**Item: 245kV CT**

**Ratio: 400/1A, 1C**

**Customer: APTransco, Andhra Pradesh**

**List of Standard Drawings/Documents:**

TITLE : GENERAL ARRANGEMENT  
245KV CT  
APTR-05.31.245J1  
SHEET 1 OF 1  
REV. NO. : 00

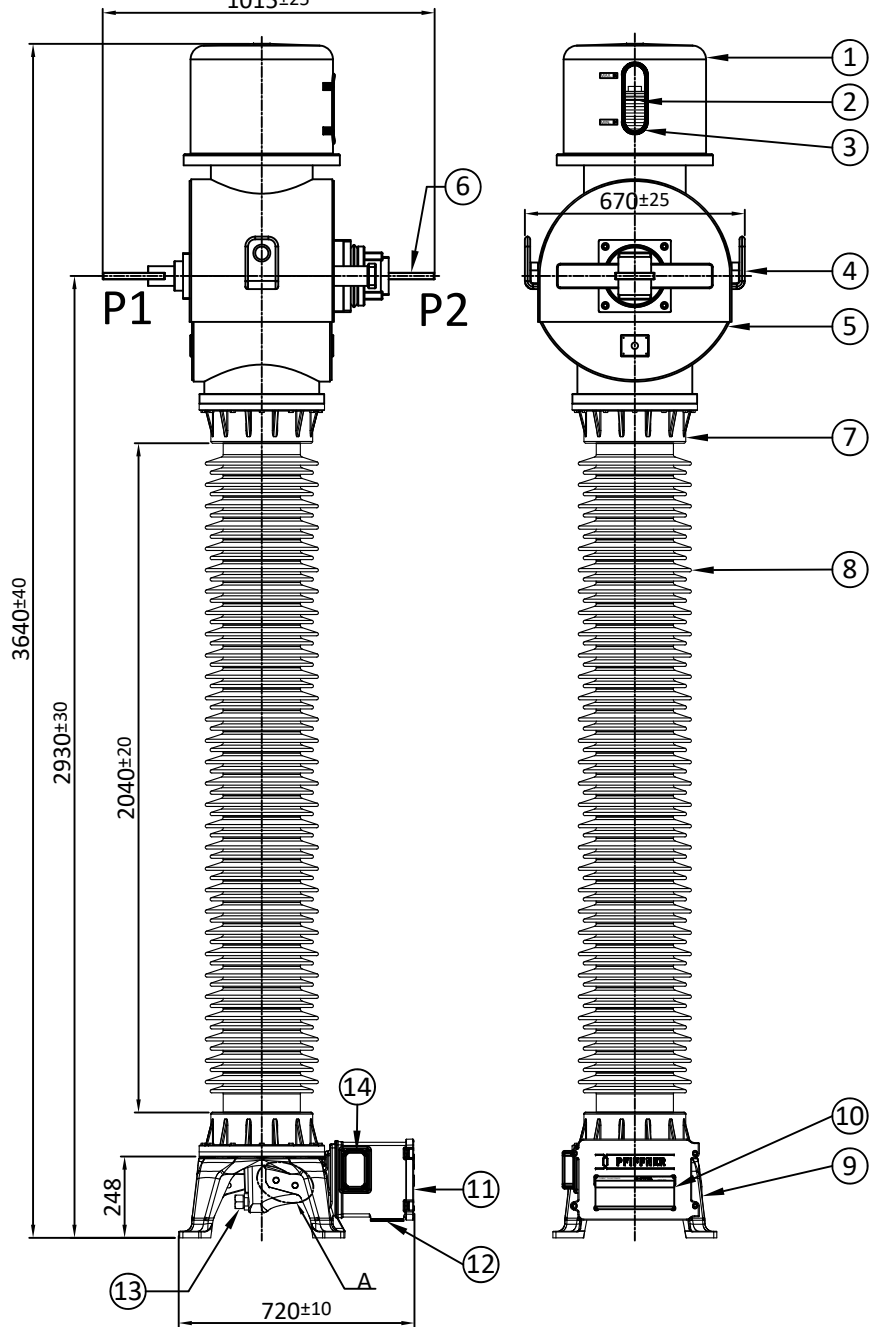
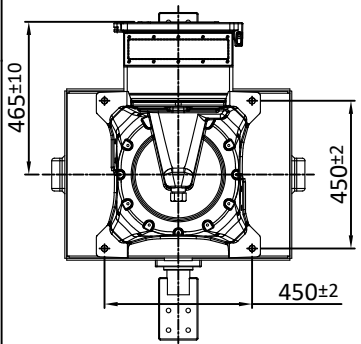
NOTE:-1. Drawings approval subject to valid type test reports,  
 to be checked during acceptance tests.  
 2. For EPC contractors only.

Drawing approval subject to valid vendor registration

Variation of Tan Delta Value from 10KV  $\mu\text{m}/\sqrt{3}$  shall be not exceed 15%.

1. Minimum 300mm plinth shall be maintained for CT/PT/CVT/ Isolators/IVT in the substation during foundation works to ensure safe live to ground clearance as per IE rules.
2. Since the supply of terminal connectors is not in the scope of manufacturers as mentioned in the drawings. The EPC contractors shall be instructed to supply the same in line with CT/PT/CVT/Isolator /IVTs requirement and capatibility.

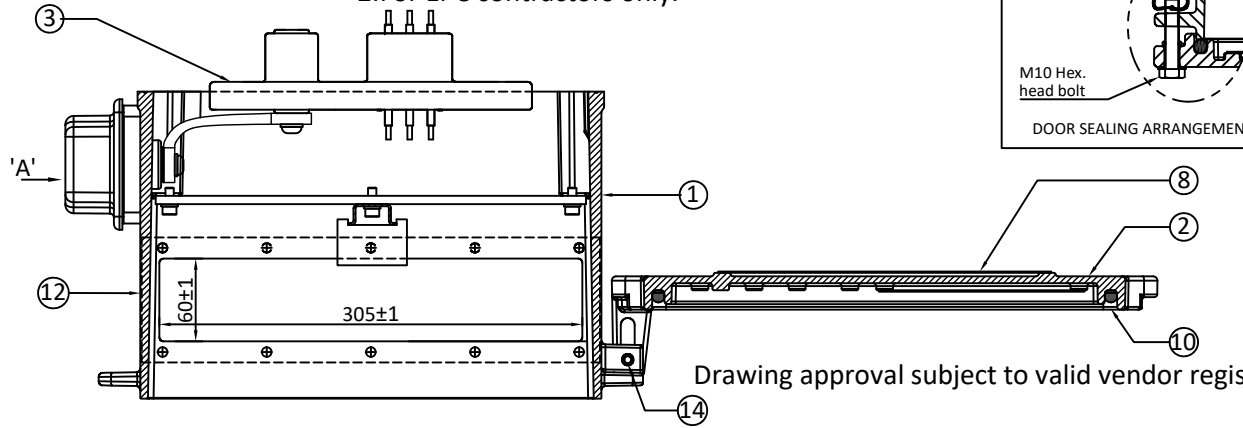
Variation of Tan Delta Value from 10KV um/sqrt 3 shall be not exceed 15%.

NOTE:-1. Drawings approval subject to valid type test reports, to be checked during acceptance tests.  
2. For EPC contractors only.

Drawing approval subject to valid vendor registration

REV.NO.	DESCRIPTION	APPV'D	REV. DATE
01			
GEN. TOL : NA		MATERIAL : NA	
WEIGHT : NA		SPEC : NA	
DRAWN	DHM	18.04.2023	FINISH : NA
CHK'D	CHM	18.04.2023	SCALE : N.T.S.
APPV'D	CHM	18.04.2023	SHEET SIZE : A3
			DWG NO.
TITLE : TERMINAL BOX GA 245KV CT			APTR-05.31.245J3
SHEET 1 OF 1			REV. NO. : 00

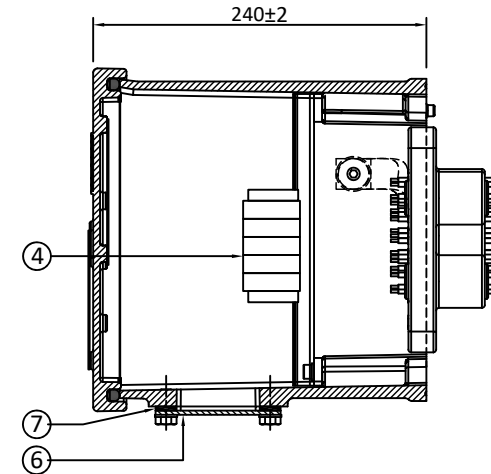
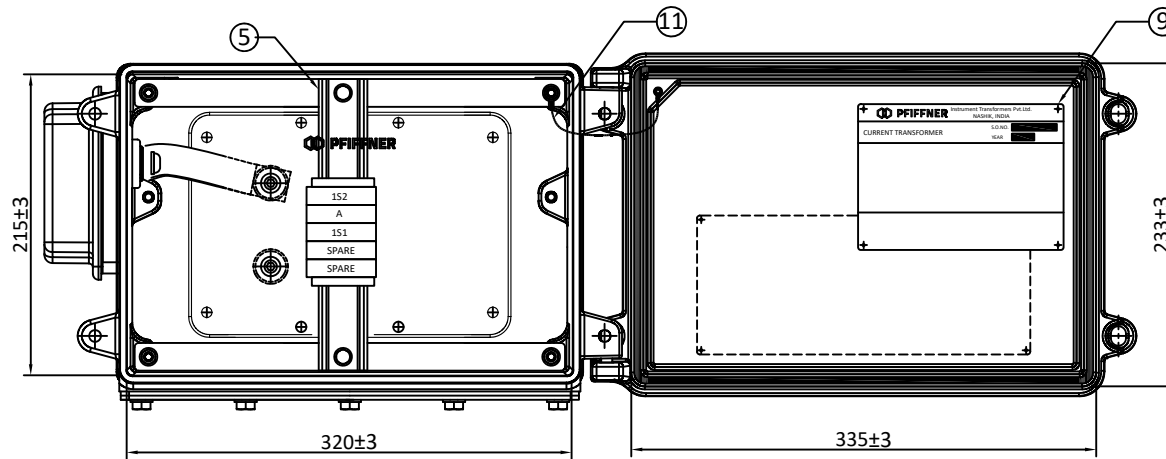
NOTE:-1. Drawings approval subject to valid type test reports,

to be checked during acceptance tests.

2. For EPC contractors only.

Drawing approval subject to valid vendor registration

Variation of Tan Delta Value from 10KV um/sqrt 3 shall be not exceed 15%.

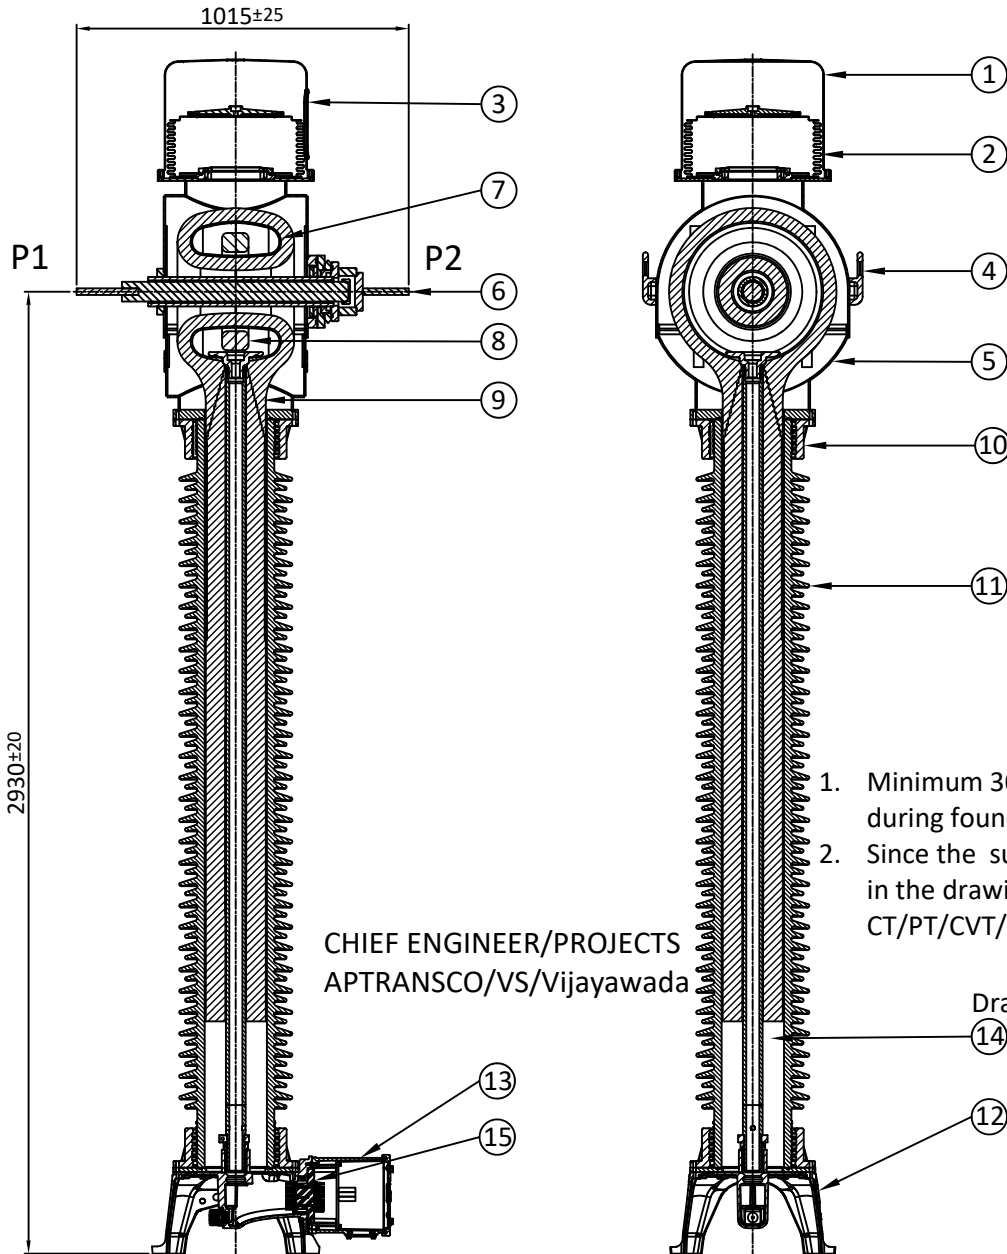
NOTE:-1.Drawings approval subject to valid type test reports,  
to be checked during acceptance tests.  
2.For EPC contractors only.

1. Minimum 300mm plinth shall be maintained for CT/PT/CVT/ Isolators/IVT in the substation during foundation works to ensure safe live to ground clearance as per IE rules.
2. Since the supply of terminal connectors is not in the scope of manufacturers as mentioned in the drawings. The EPC contractors shall be instructed to supply the same in line with CT/PT/CVT/Isolator /IVTs requirement and capatibility.

Drawing approval subject to valid vendor registration

Variation of Tan Delta Value from 10KV um/sqrt 3 shall be not exceed 15%.
